ADDENDUM NO. 2

Reference: Vernal Game Farm New Shop and House Renovation
Division of Wildlife Resources – Vernal, Utah
DFCM Project # 07319520

ADDENDUM NO. 1
Date: May 26th, 2009

Vernal Division of Wildlife Resources
New Shop Building, Office Remodel and Site Improvements
Vernal, Utah

A-WS401

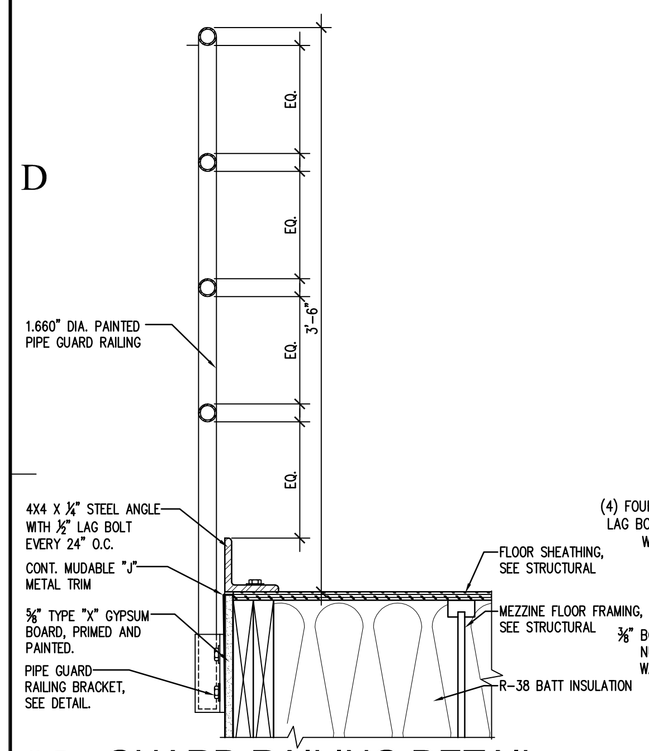
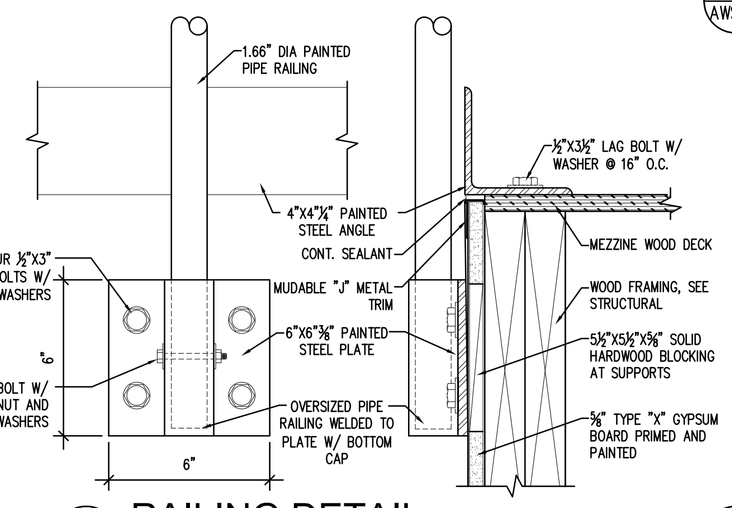
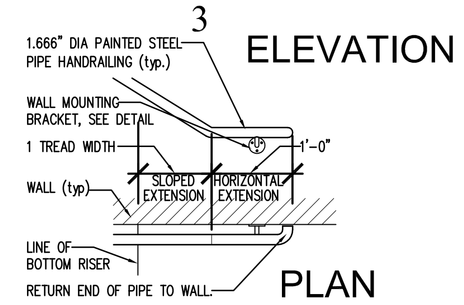
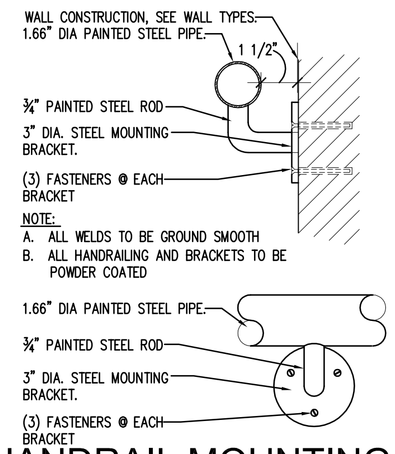
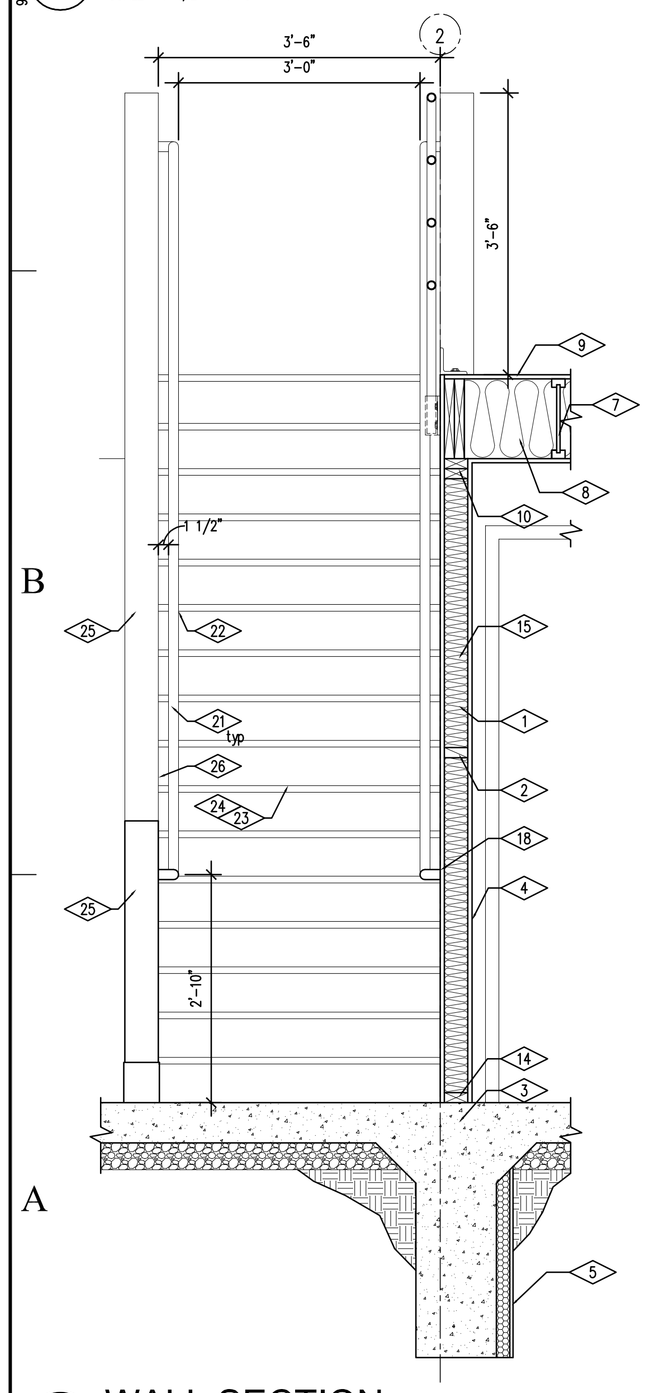
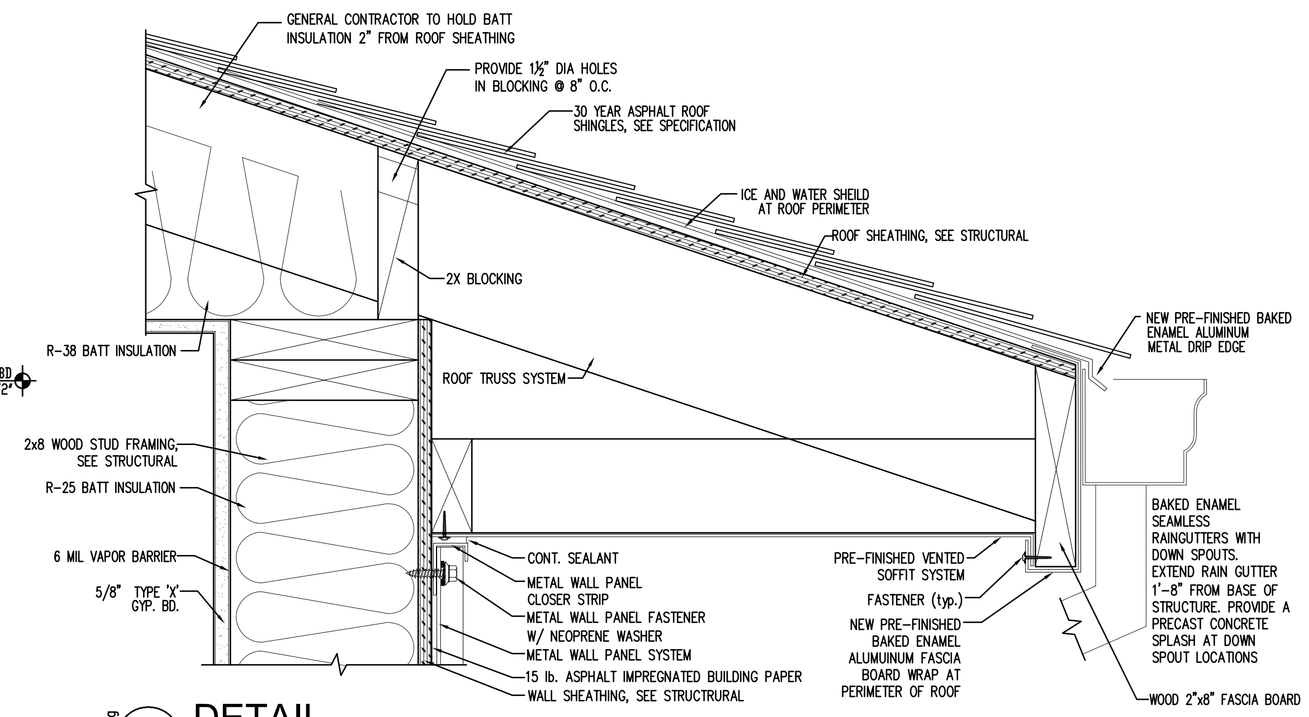
2. See revised drawings A-FP100, A-BS300, A-WS401. Note changes to floor plan and new stair configuration. The ships ladder as per the original plans will not be provided.

SHEET NUMBER
C101

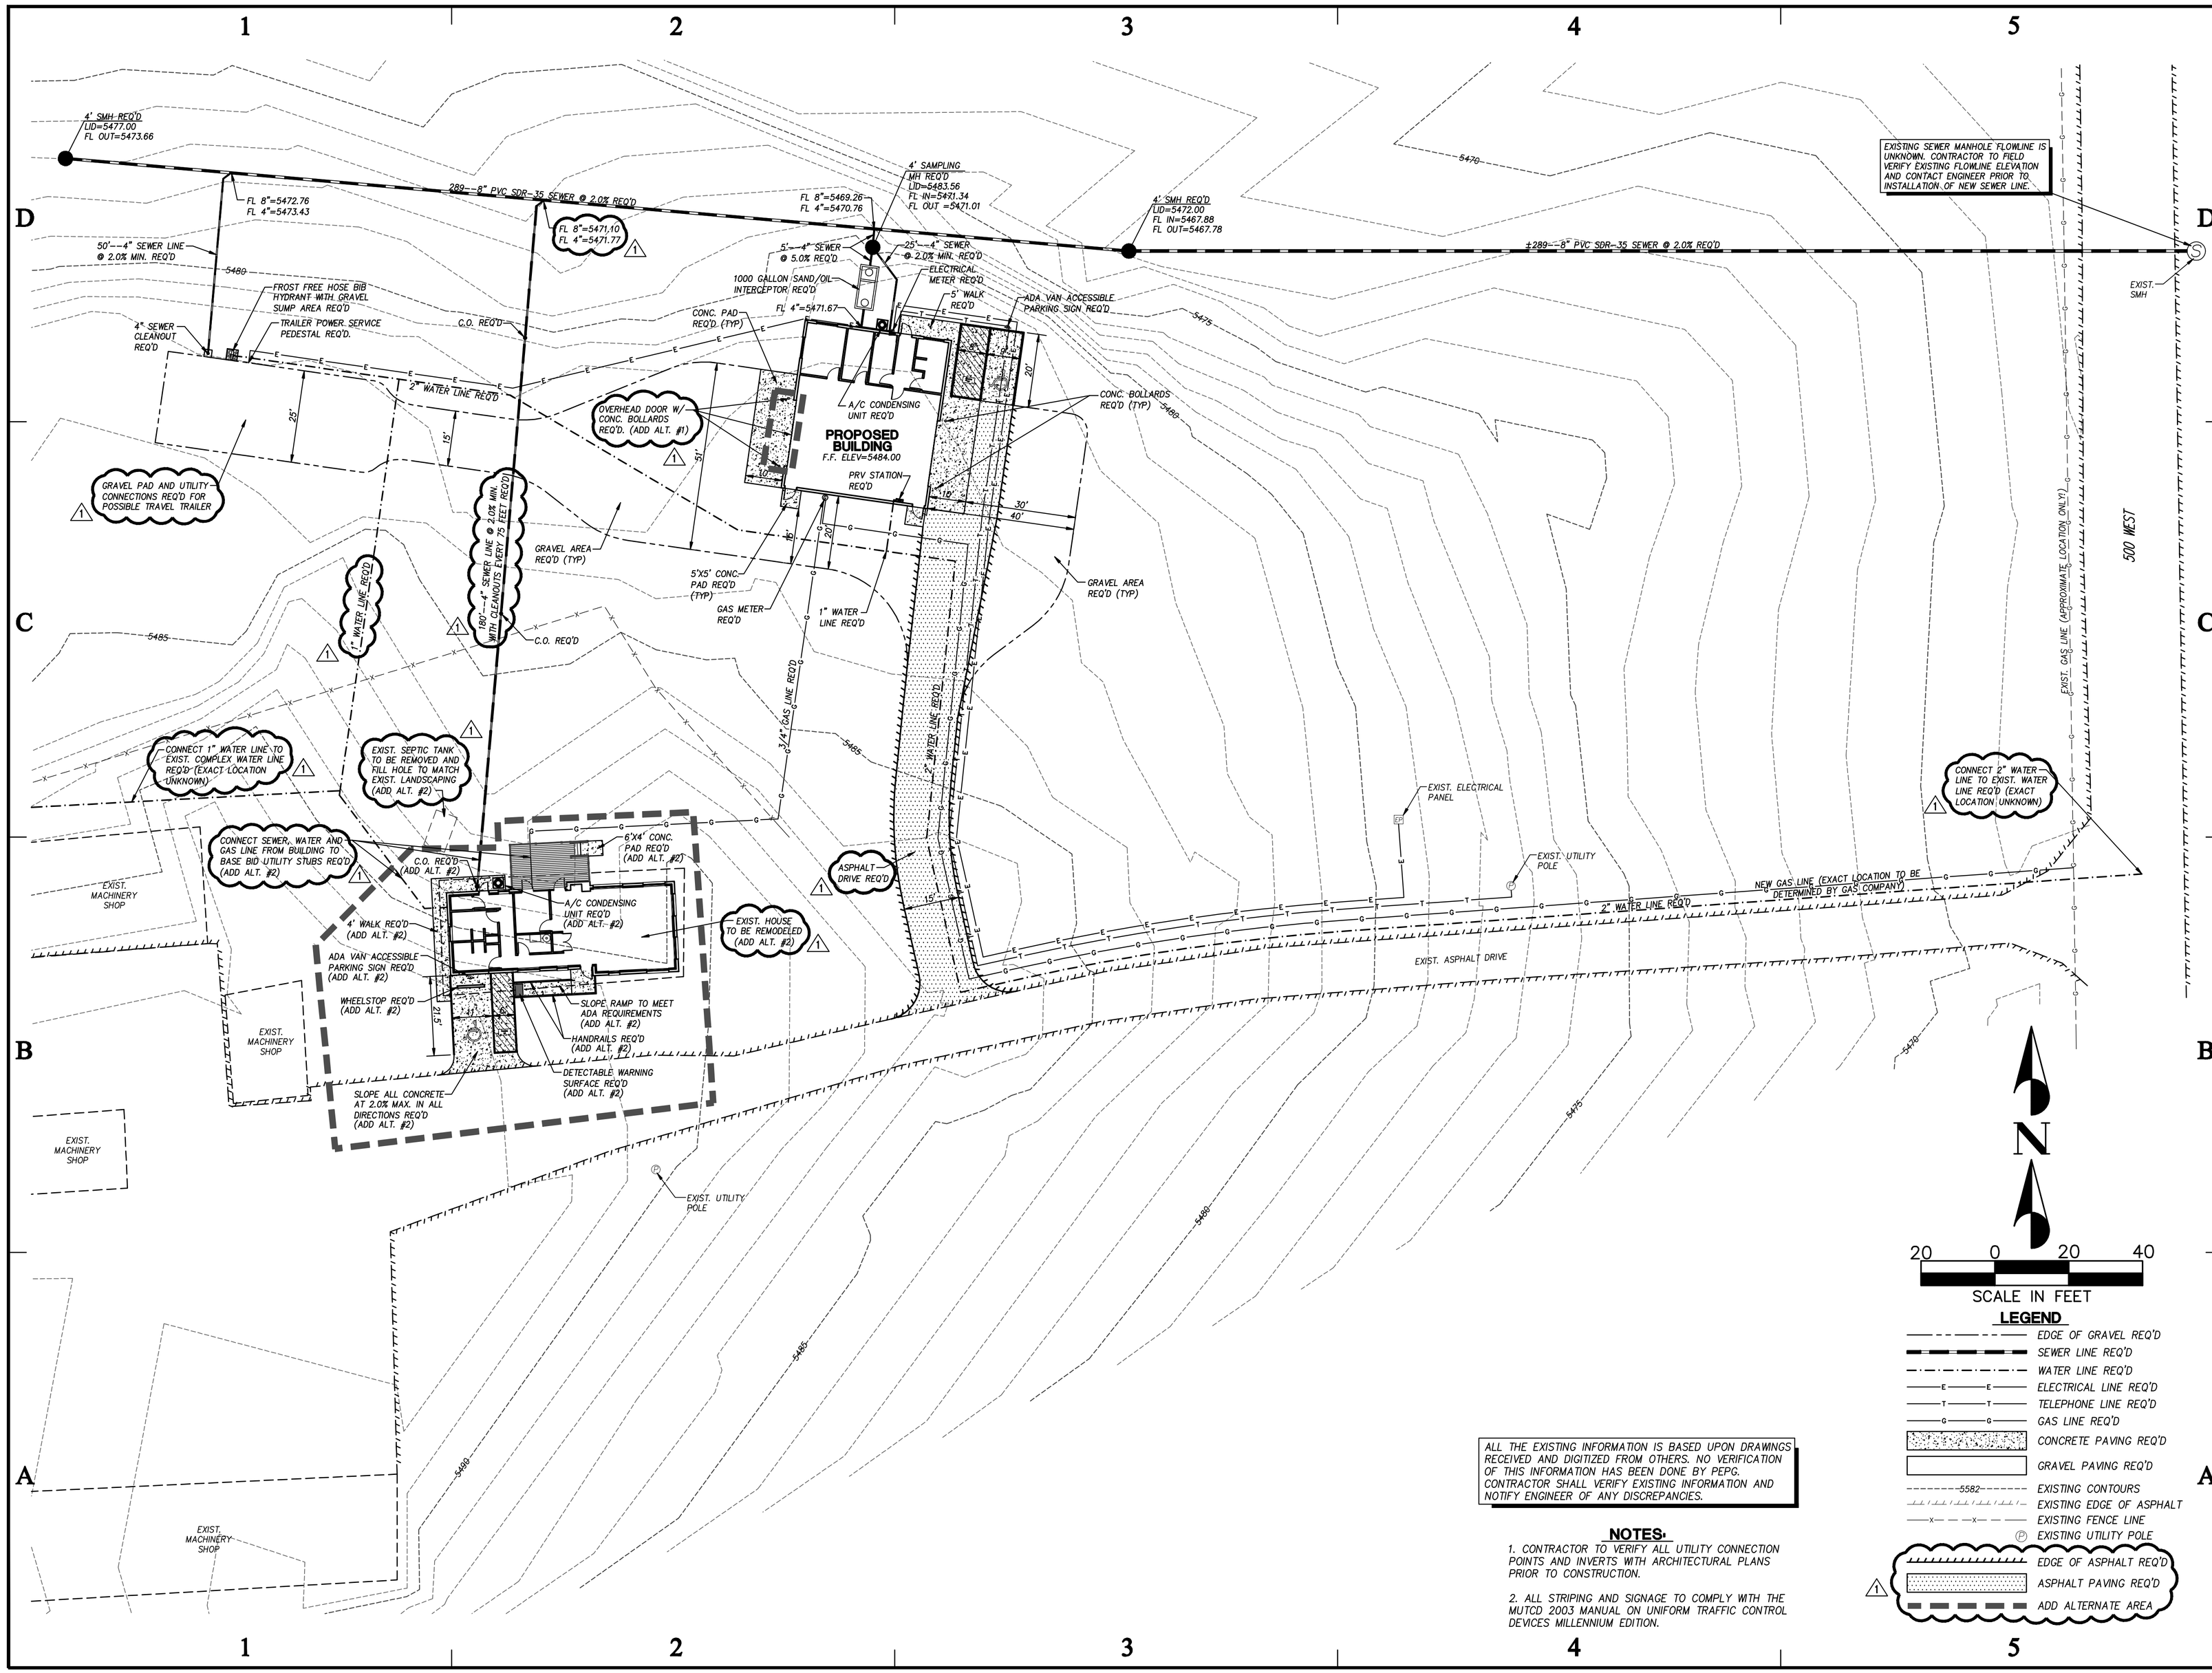
1. See civil engineering drawing C101attached with this addenda. Note, all items associated with the house remodel to be bid as add alternate #2. All new utilities to the existing house shall be stubbed as close to the house as possible and marked as part of the base bid.
